Oaks Preserve Design Plat

City Commission

December 6, 2018

Legistar # 171022

Condition #1:

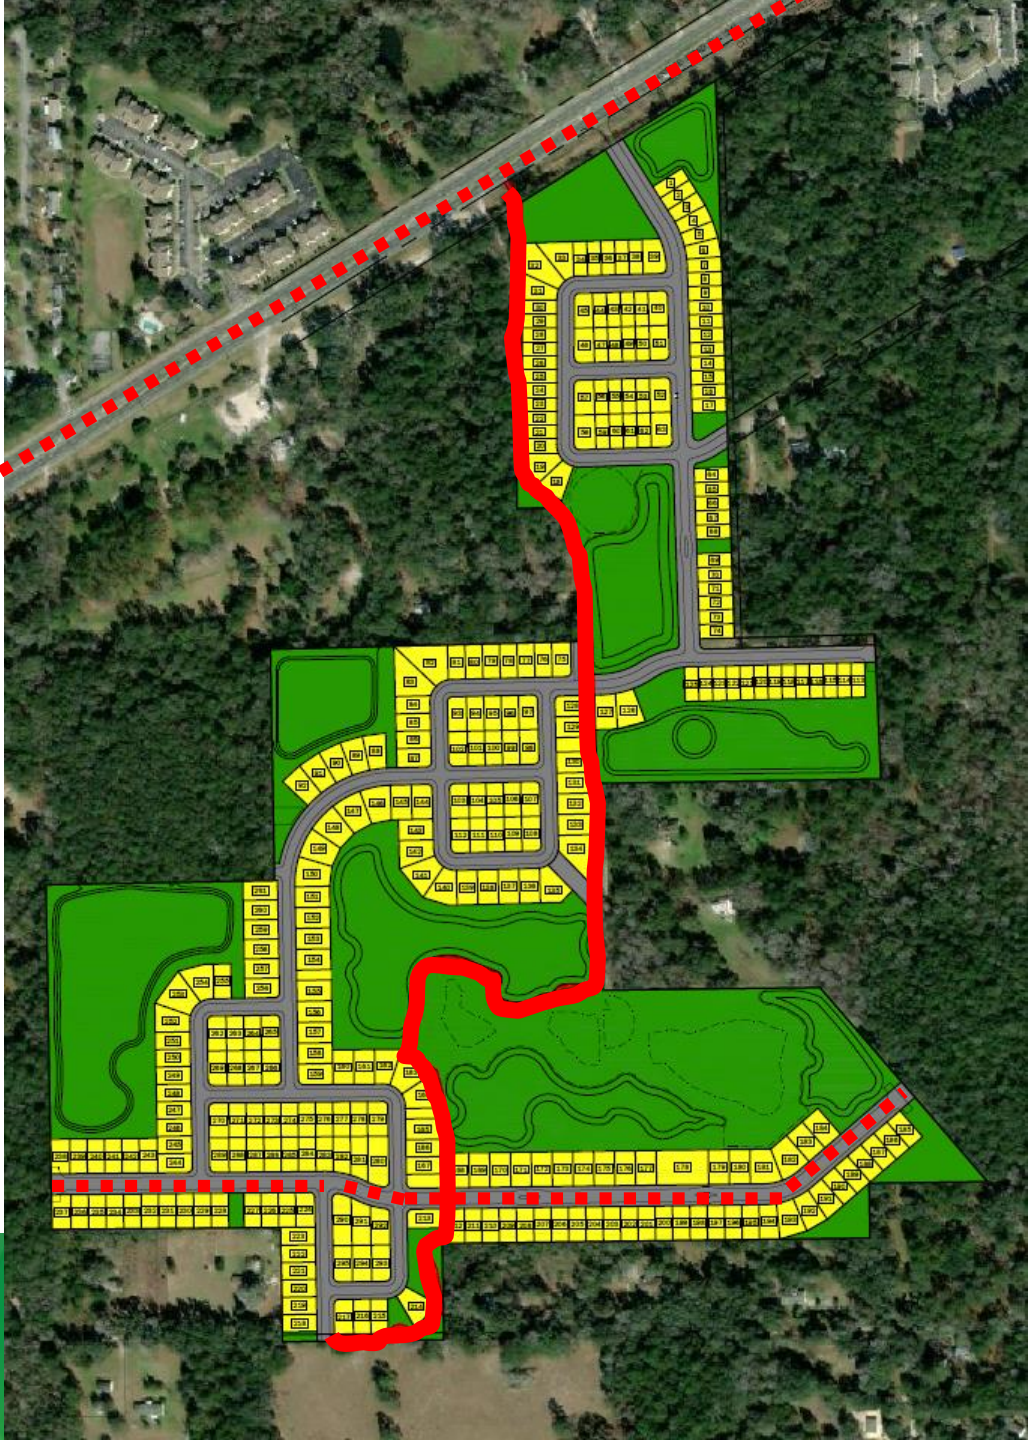
The north/south trail shall be reconfigured to run as an independent route and shall not be designed as a shared path within the proposed rights-of-way. The trail shall be designed as a 10-foot wide multi-use trail and shall be routed at the back of lots.

- **Trail Relocation**
- **Entirely off Streets**
- **North to South linkage**
- **Connectivity to Archer Rail Trail & Bike Lanes on Road Q**
- **Public Access Easement**
- **HOA Maintenance**

Condition #2:

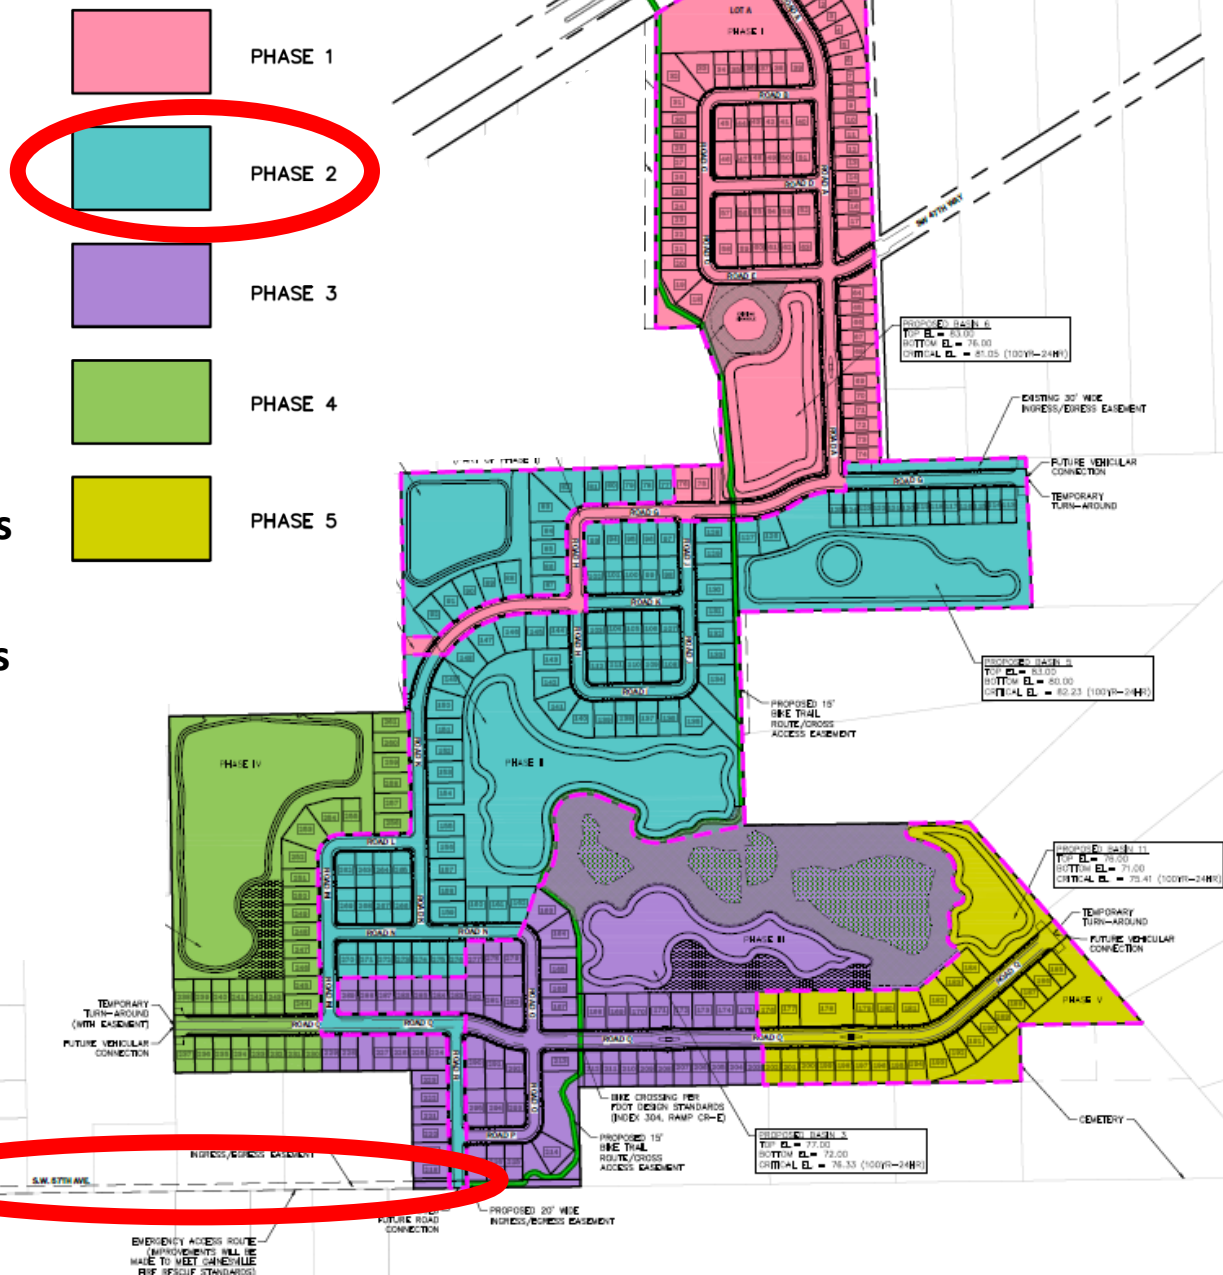
The right of way corridor provided between lots 135 and 136 for access to tax parcels 06952-001-000 and 06952-003-000 shall be expanded to a minimum width of 50 feet.

- **ROW between lots 135 & 136 expanded to 50 feet in width**

Condition #5:

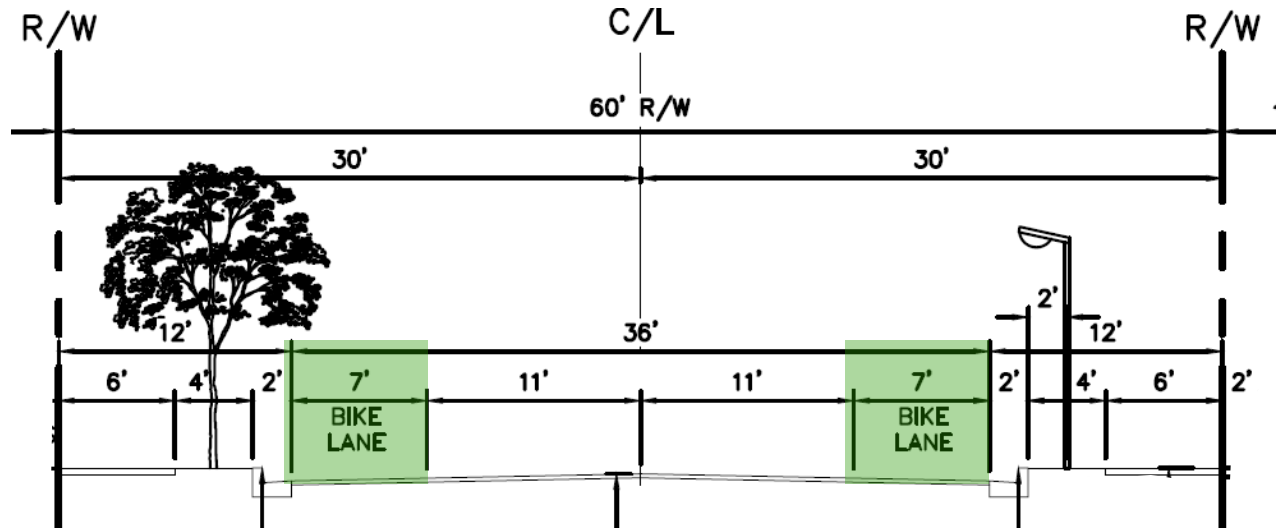
A 7-foot wide buffered bike lane shall be constructed on both sides of Road "Q"; the design shall be resubmitted to the City Commission for final approval.

- Road Q redesigned to comply with condition
- Design reviewed and approved by City Staff
